Project: 08-25-3311 HCA LSMC CAMPUS EXPANSION
2100 SE BLUE PARKWAY
LEE'S SUMMIT, Missouri 64063

RFI #024: Struct. - DietEx Steel Deck & Bent Plate Dimensions

6 TYPICAL SECTION AT ROOF

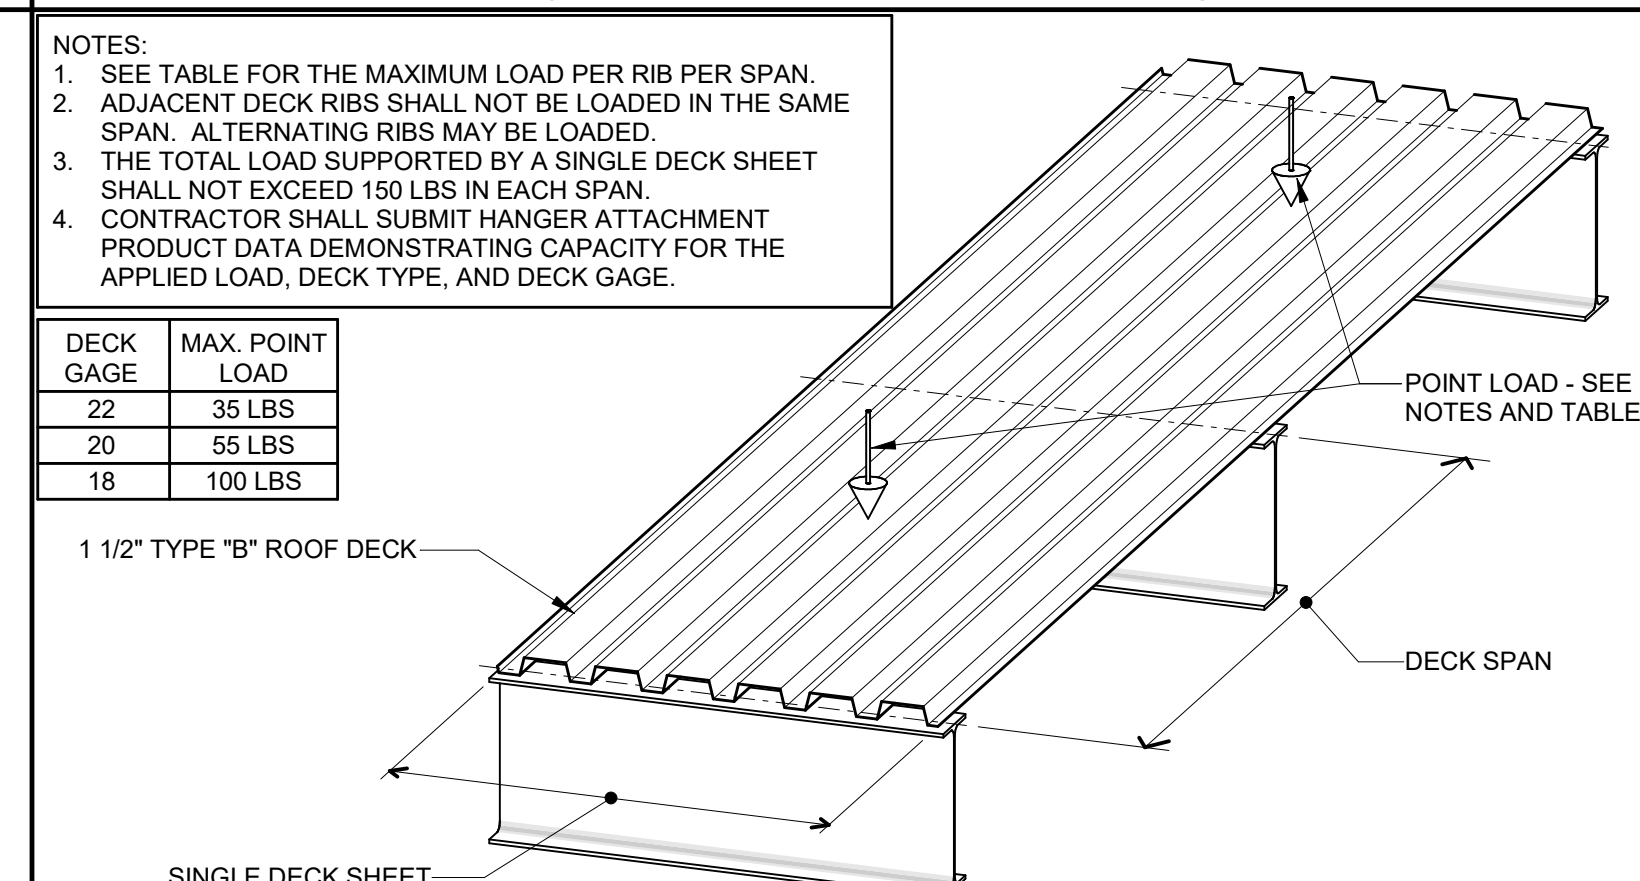
Q2: Detail 6/S303 indicates for bent plate height to be coordinated with architectural. The Architectural drawing does not show height for bent plate in 3/AE501. 3/AE501 appears to correlate to 6/S303 which indicate a minimum bent plate height of 5". Architect to confirm height of bent plate to be provided.

**BENT PLATE HEIGHT NEEDS TO EXTEND PAST THE
ROOF SLAB MINIMUM OF 1 INCH. - MATT MCDANIEL**

1 TYPICAL ROOF DECK ATTACHMENT
(1 1/2" TYPE "B" ROOF DECK)

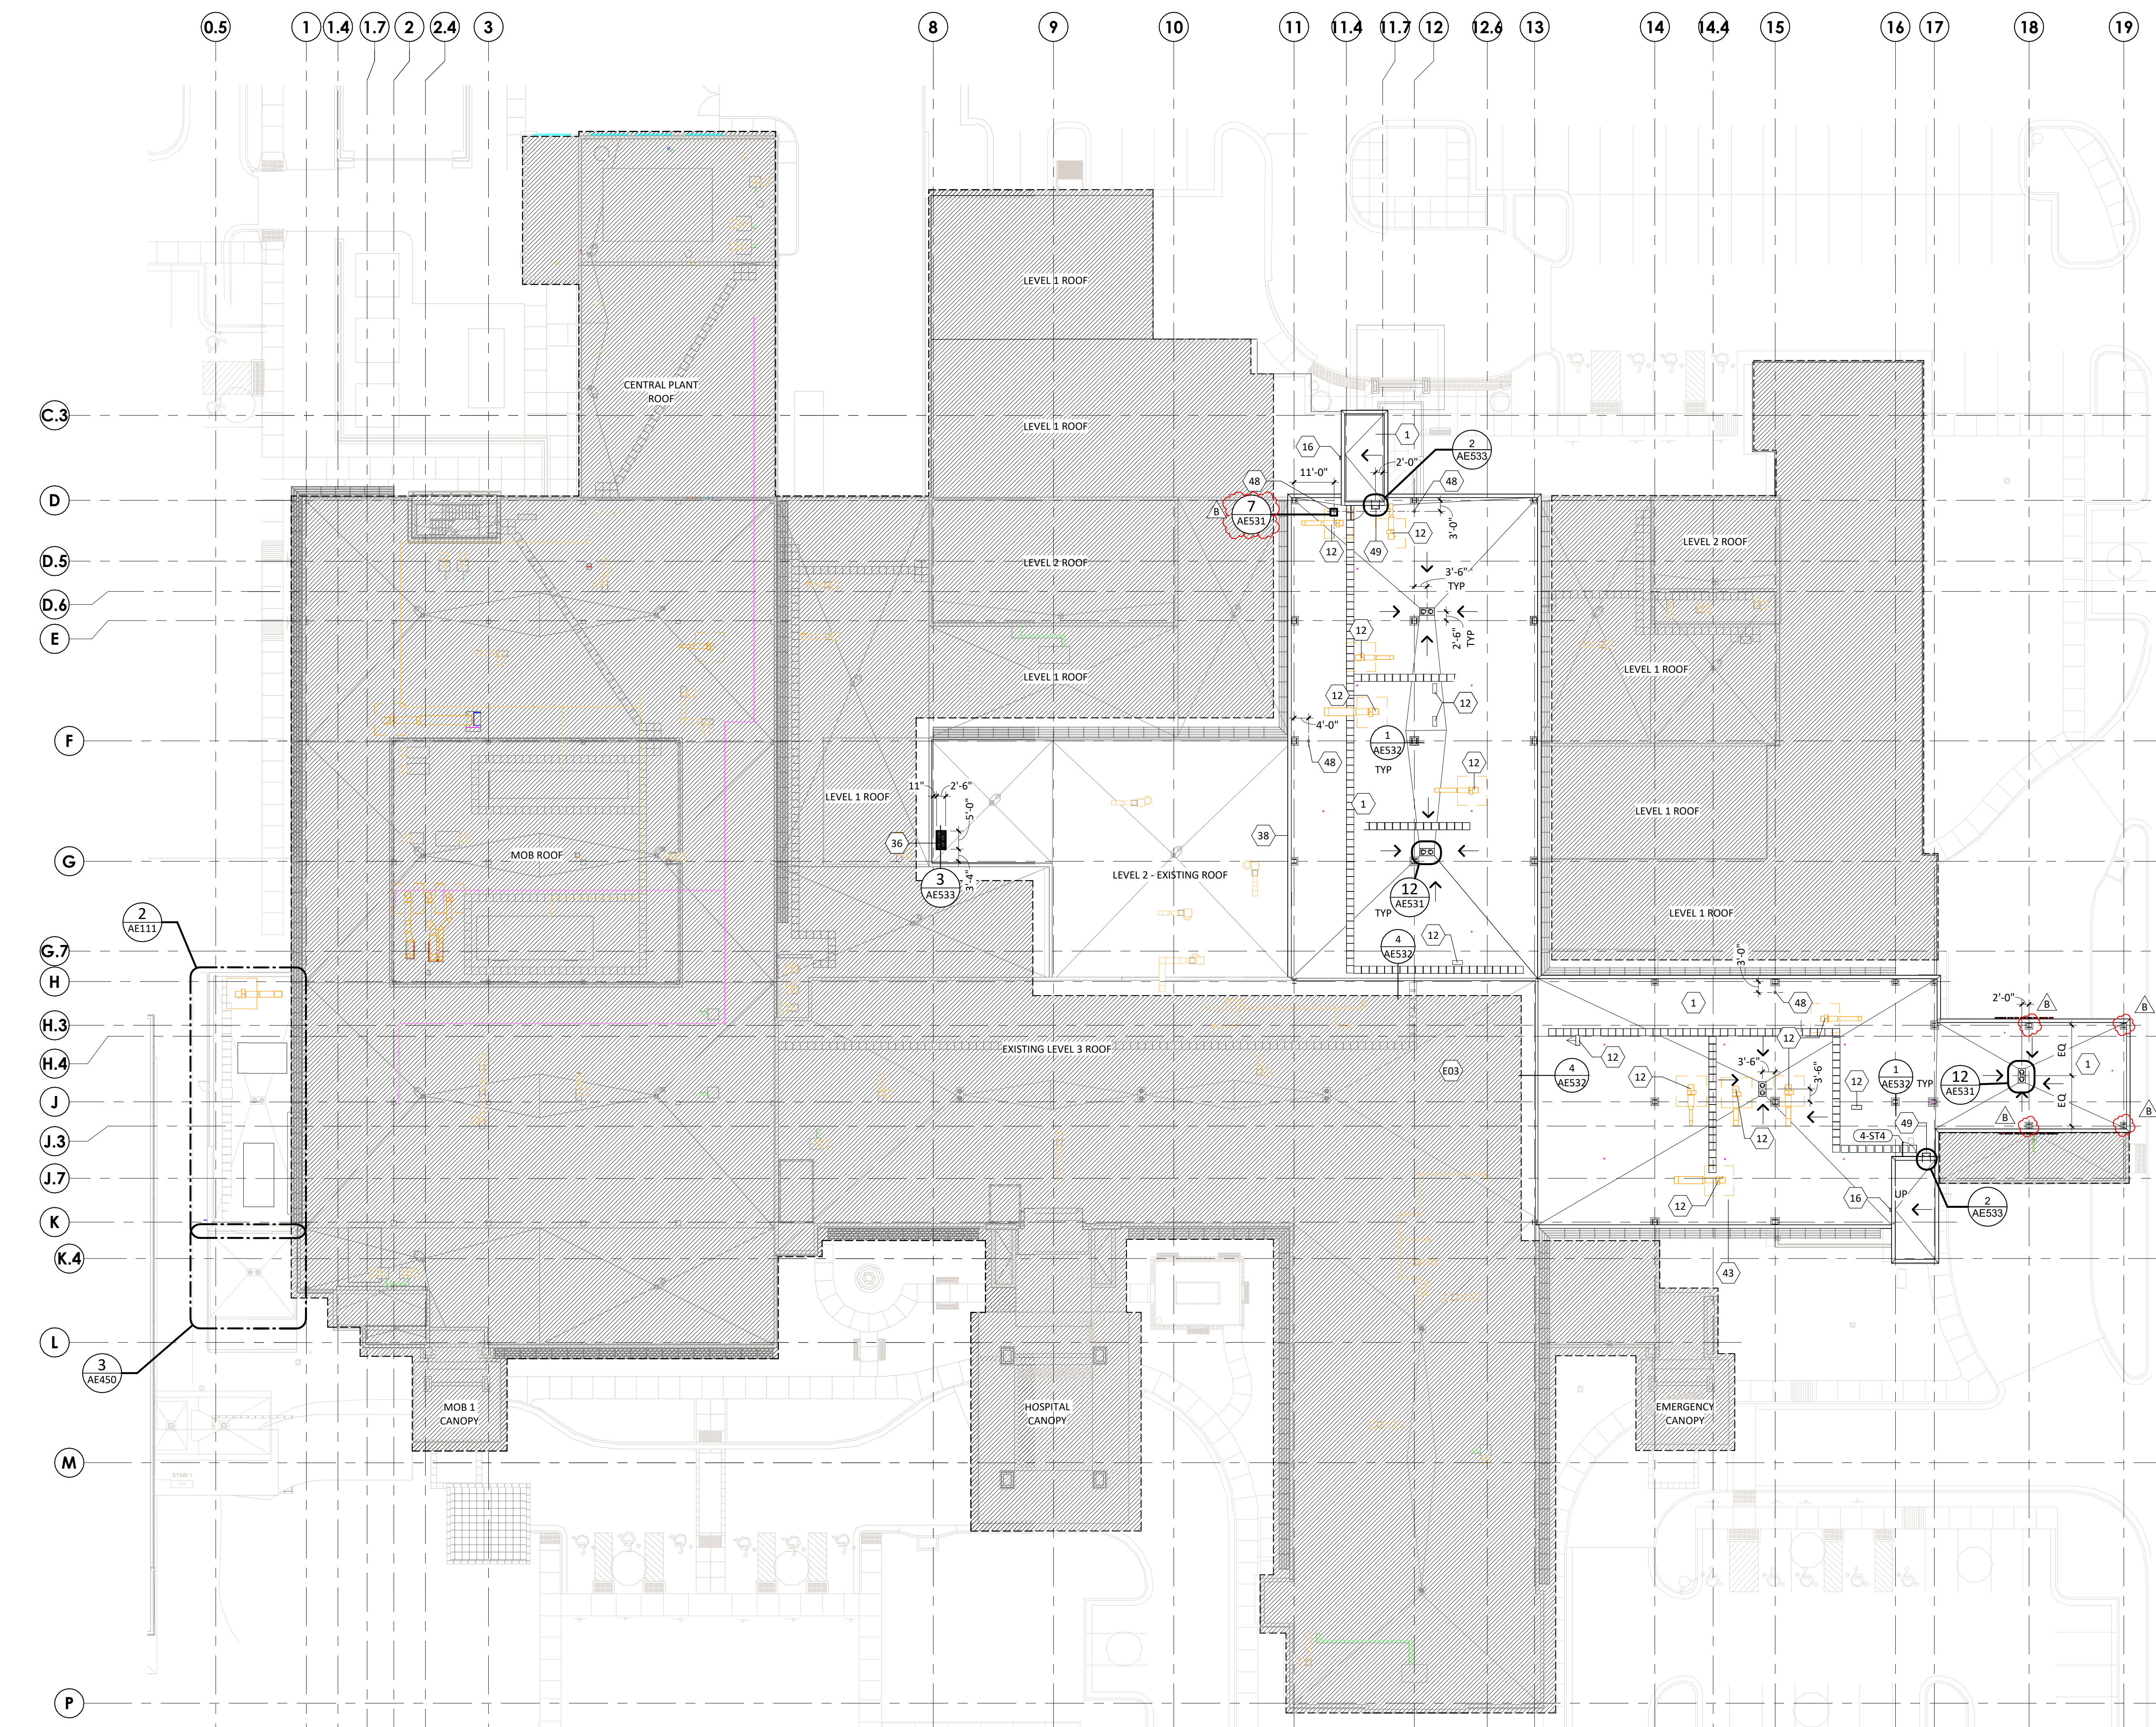
Q1: Sheet S122 and detail 1/AE311 call for the steel metal deck to be 1-1/2" at Dietary expansion. Architectural detail 3/AE501 calls for the steel metal deck to be 2". Design Team to confirm the height of steel deck at Dietary roof expansion.

**STEEL DECK TO FOLLOW STRUCTURAL DRAWINGS
- MATT MCDANIEL**
